## SERVICE BULLETIN

**APPLICABILITY:** 2020-**24**MY Legacy & Outback  
2023-**24**MY Ascent

**NUMBER:** 07-213-22R

**SUBJECT:** Genuine Battery Replacement

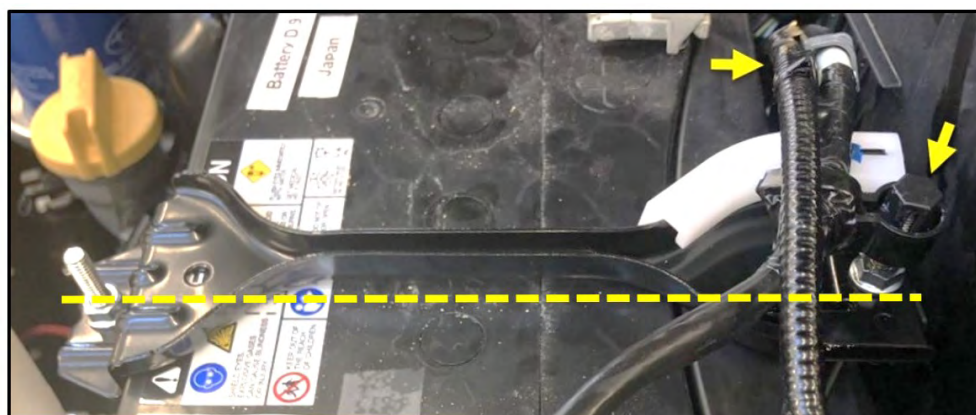
**STEP 5:** Assemble the new battery holder (p.n. 82184SG000), NEW rear holding rod (p.n. 82161SJ000), and the ORIGINAL front holding rod as shown below. The original rod nut can be transferred to the new rear holding rod.
